IV. PUBLIC HEARING
a. Horizon Pointe Subdivision Appeal (File No. 711-26-000147-A)

STAFF RESPONSE TO APPLICANT'S STATEMENT OF APPEAL
File No.: 711-26-000147-PLNG (A)
August 12, 2026

Tentative Subdivision Plan
711-26-000013-PLNG (SUB)
Horizon Pointe Subdivision

2. **DEAD END ROADS AND TURNAROUNDS:** Dead end fire apparatus access roads in excess of 150 feet in length shall be provided with an approved turnaround. Diagrams of approved turnarounds are shown below: (OFC 503.2.5 & D103.1)

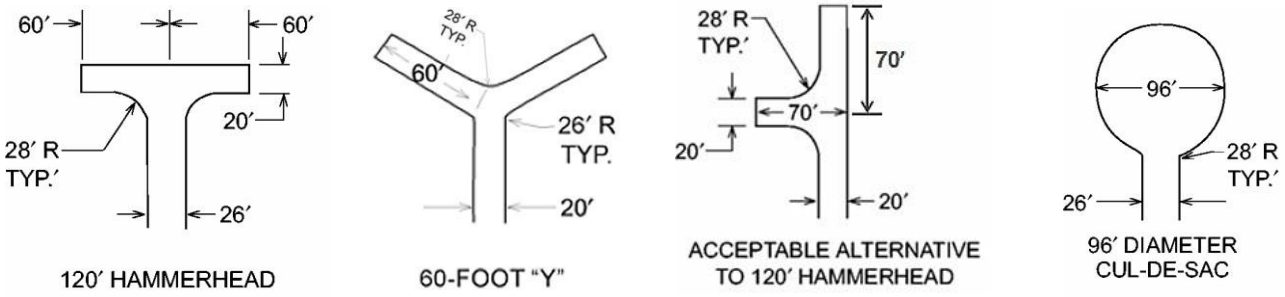
Cul de sacs are not measuring out at 96 feet. If a mountable curb with rated sidewalk is

proposed, then no parking will be allowed within the cu de sacs.

EXHIBIT 2

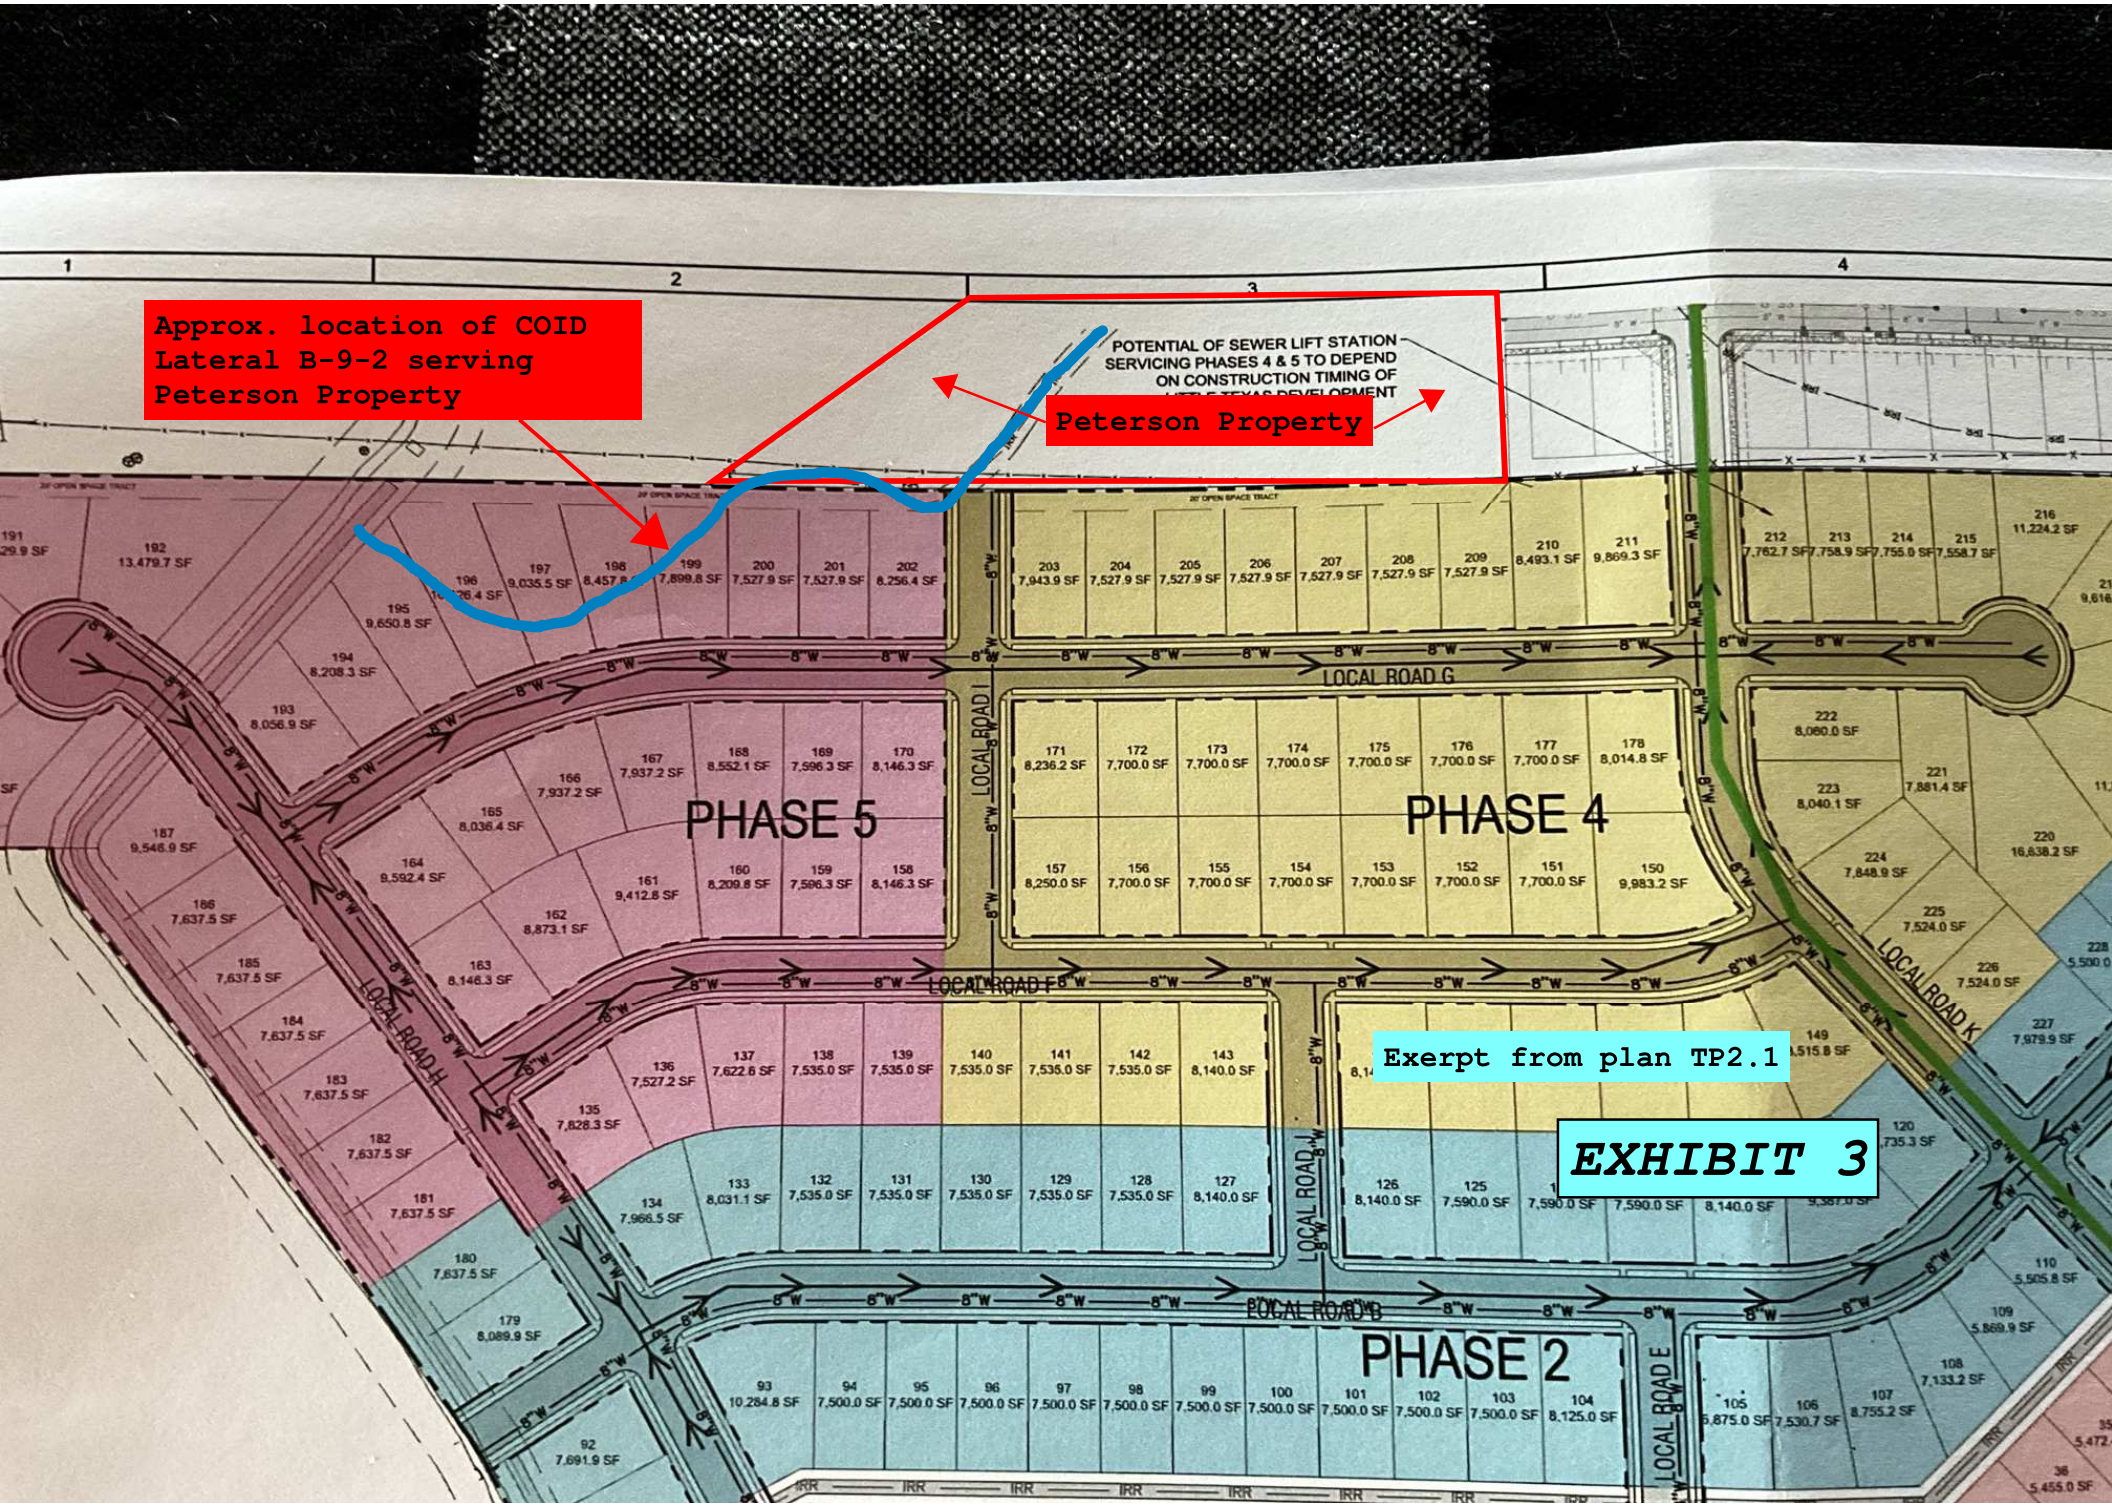
2. Page 36 of 43 (See Exhibit 2 attached) – Paragraph 7. Easements:
   - **Statement**: Applicant Response: line 3 recognizes that there are two COID delivery ditches (B-5-1 and B-9). Delivery ditch B-9-2 serves our property to the north of the proposed development. The last sentence of the response states that the applicant has been coordinating with COID for the piping and requirements of working within and around the easements.
     Peterson comment/concern: No where does the applicant address what is planned for maintaining the ditch B-9-2. In addition, this ditch is not even shown on the preliminary plan TP2.1 showing preliminary lot layouts. See Exhibit 3 attached to this letter for an extract from drawing TP2.1 showing the approximate location of this ditch in relation to the lot plans. It appears that the only resolution to this issue it to relocate and/or pipe the ditch from the canal to our property. For this reason, we request that this application not be recommended for approval until this is adequately addressed with both ourselves and COID. In the alternative, if this application is recommended for approval that a condition be included addressing this in the future.

EXHIBIT 4

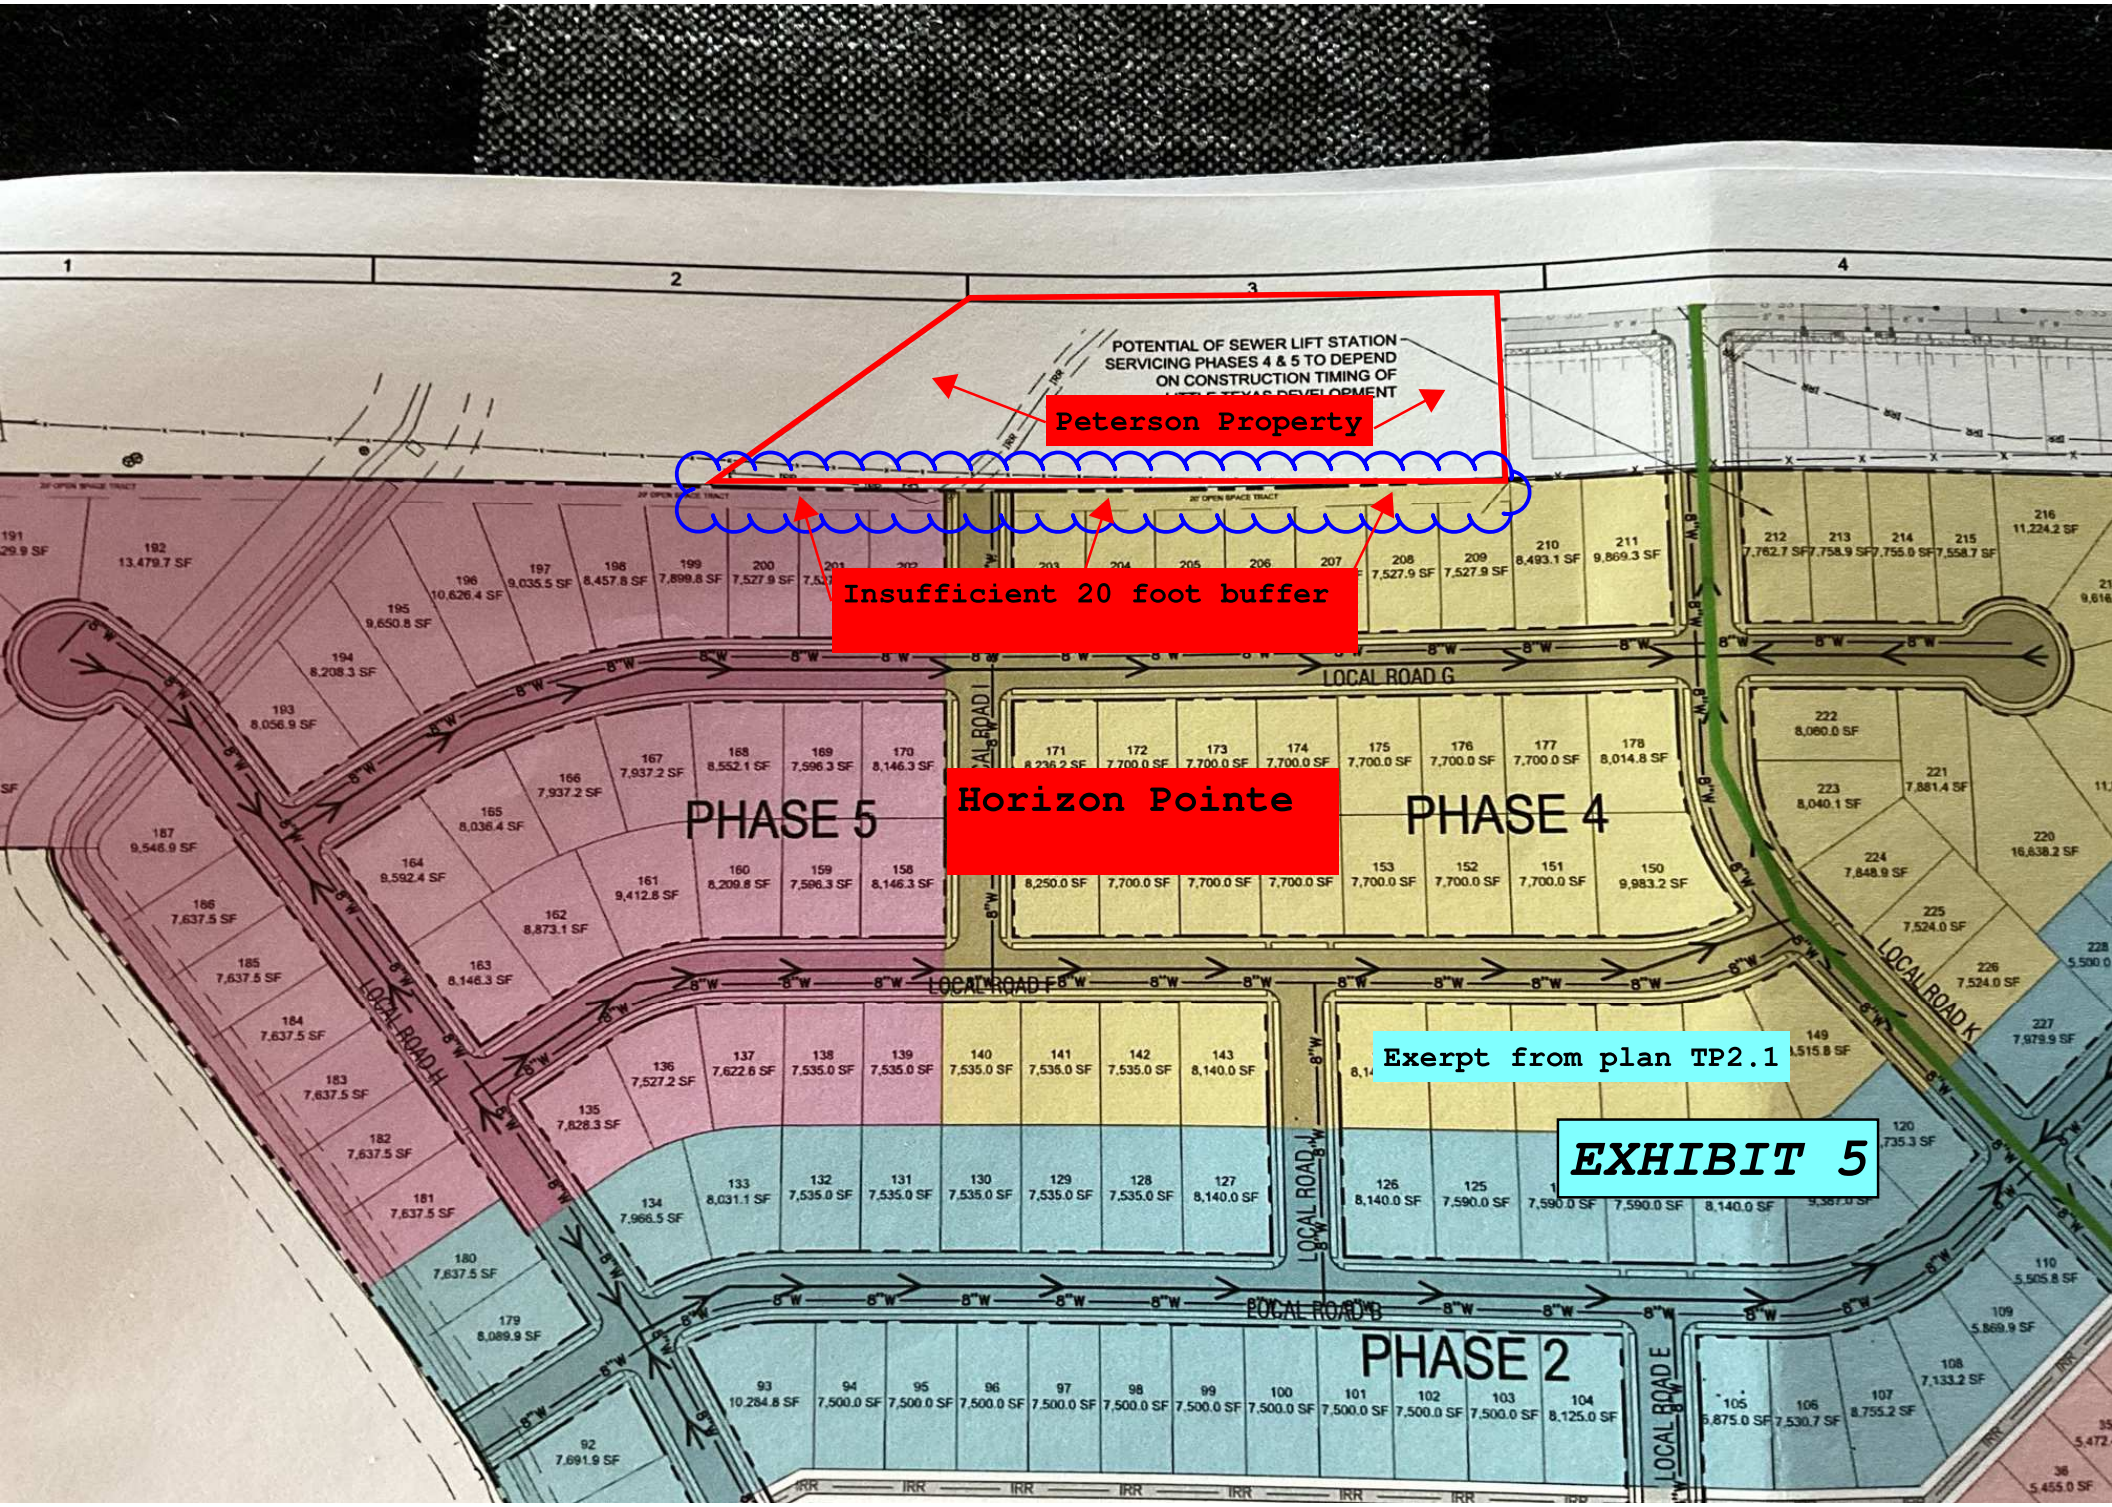
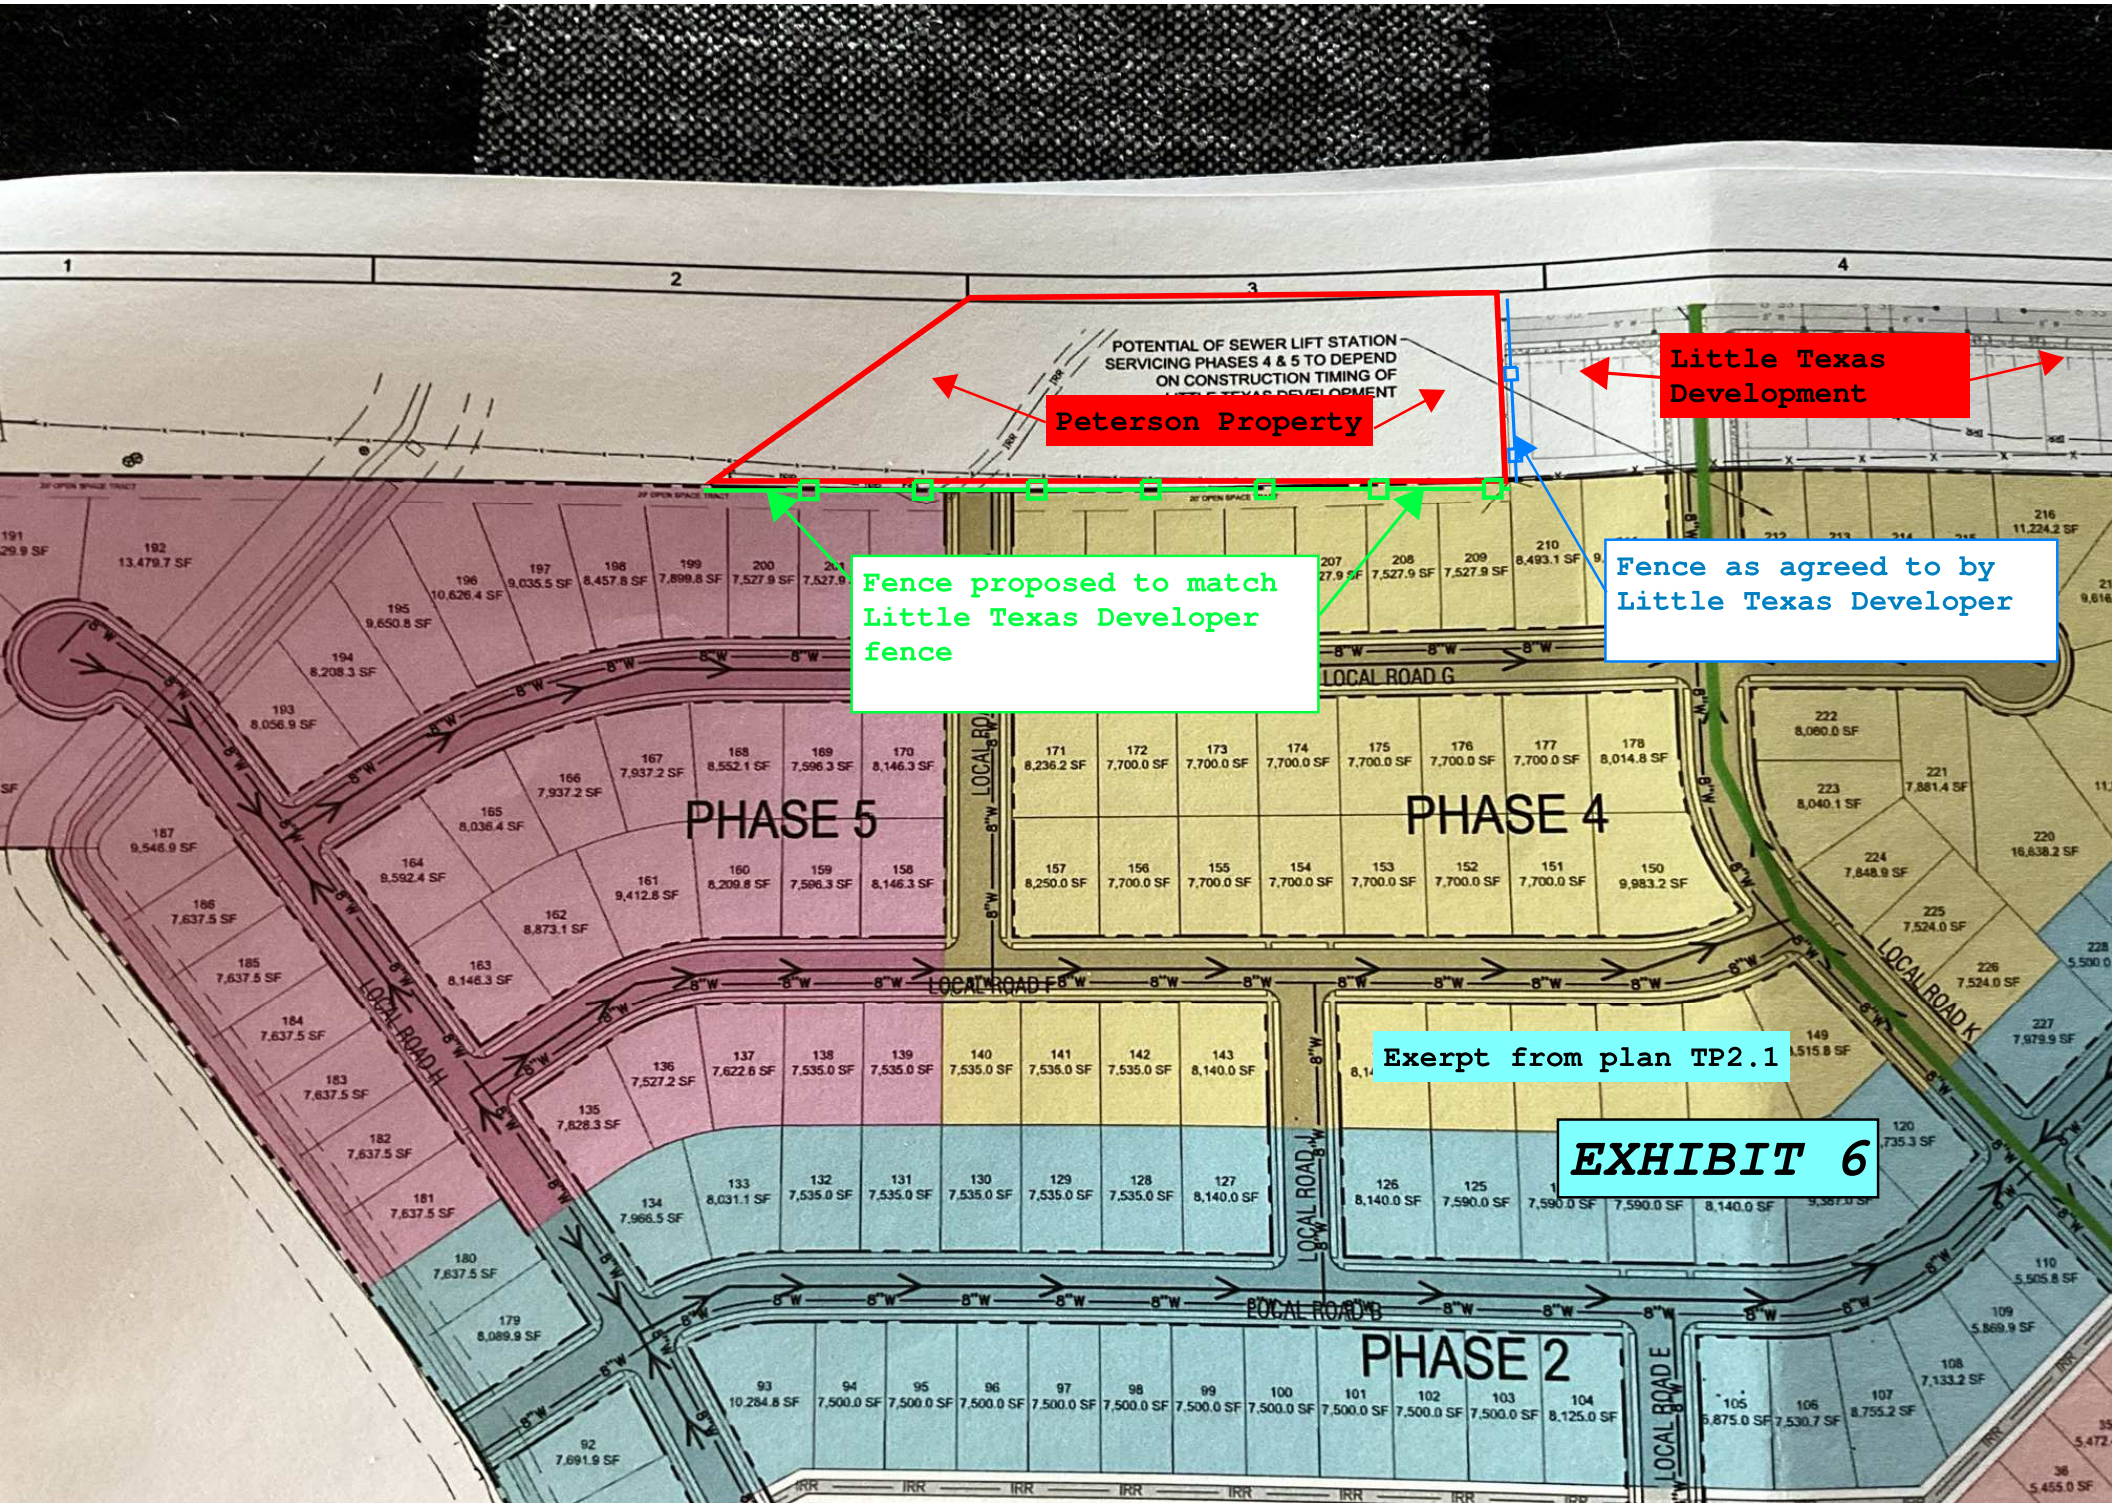
3. Page 37 of 43 (See Exhibit 4 attached) – Urban Rural Inerface:
   - **Statement:** Applicant Respnse: It is stated in the last sentence of the response that the planned open space adjacent to our lot 101, which is zoned EFU, to the north of the proposed development "will provide adequate buffering between the existing rural farmland and the proposed urban development". The applicant suggests that a 20 foot grass buffer is an adequate solution.

Peterson comment/objection: While this may constitute a buffer between residential developments, it certainly doesn't come anywhere near an appropriate "buffer" (barrier) between residential and rural farm properties. See Exhibit 5 attached that shows the adjacency of the Horizon Pointe proposed lots to our property. Given that we also raise cattle on this property, a much more substantial barrier would need to be installed to keep the cattle and future residents apart, even though we have our property fenced with barb wire and electric fence.

We raised the same issue with the Little Texas proposed development. The developer agreed to install a 6 foot high wood fence along our property, before any construction begins. We request that the Horizon Pointe Developer install a matching fence between our properties. See Exhibit 6 showing the fence location that is to be installed by the Little Texas developer and the proposed fence on the Horizon Pointe interface. See also Exhibit 7, pages 1 and 7 listing the condition 11 of the Little Texas development that was part of the approval by the Redmond Area Planning Commission.
